CLEMENTSON RANCH  
(UNITS 1, 2 AND 3)

PUD/POADP PLAN

POADP # 674

SUBJECT: Clementson Ranch PUD/POADP Level I T.I.A.

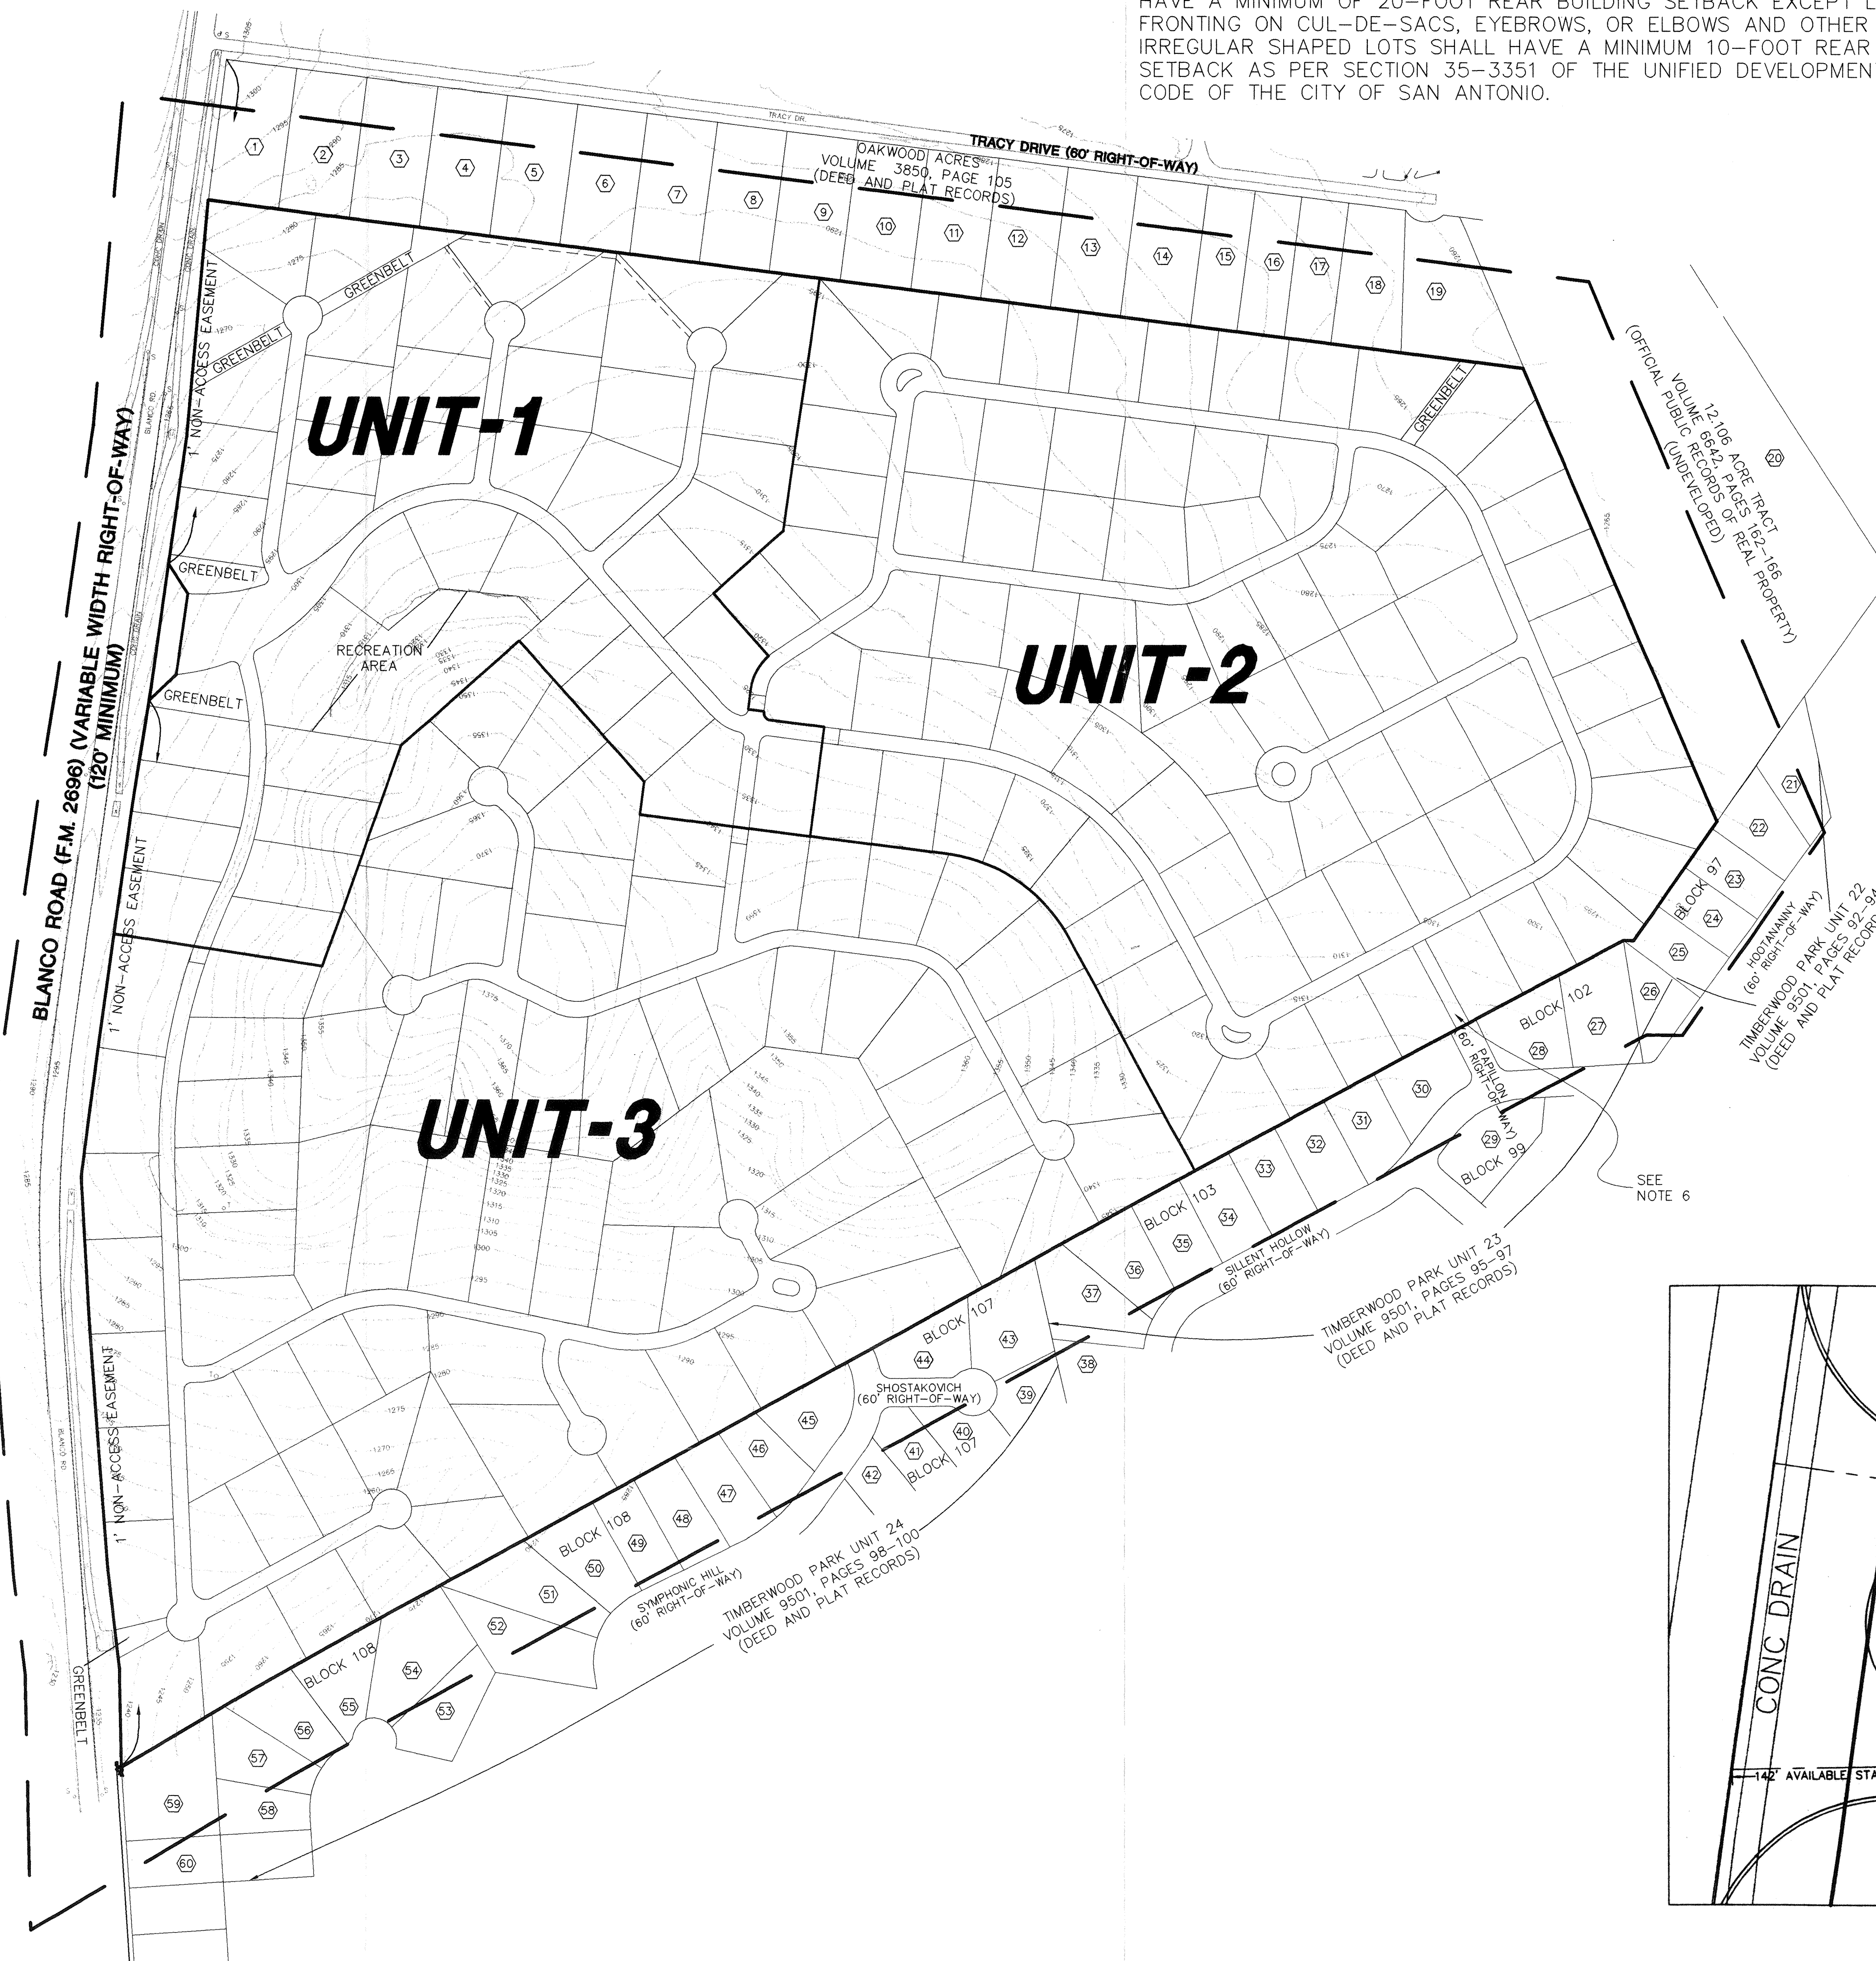
Comments: Blanco Rd (FM 2696) is on the MTP and  
TXDOT System Requiring 2 min of 86' ROW and  
TXDOT release

Comments: Blanco Rd is 2 Major thoroughfare secondary  
arterial type A requiring 80' min. R.O.W. Plat does not  
show ROW. Plat need to show R.O.W. and street dedication

<u>P.O.A.D.P. Reviewed for:</u>	<u>Comments</u>
Noise Mitigation	For residential development directly adjacent to State ROW, the developer shall be responsible for adequate set-back and/or sound abatement.
R.O.W. Requirements	FM 2696 requires a minimum overall right of way width of 120'. TxDOT will require 50' right of way flares at the intersection of FM 2696 and the proposed entry to this development.
Access Limits/Restrictions	Locations of access points will be as directed by Regulations For Access Driveways to State Highways.
WPAP Requirements	A complete copy of the approved WPAP will be required at the time of platting. State right of way will not be utilized for the purposes of treating storm water runoff from adjacent property. No access permits will be issued prior to receipt of the approved WPAP.

- TIA will be required
- ROW width needs to be shown on Blanco Road
- One foot non access easement along Blanco Road.
- Stub-out will be required, preferred location at Papillon
- Aquifer note
- Slope note
- Tree note

Attached are revised copies of the Clementson Ranch POADP and your original redline comments. We have addressed all of the comments except for the 1' non-access easement along the south property line. We feel the non-access easement is not necessary since it is not adjacent to a proposed or existing roadway, as is the case with Blanco Road.
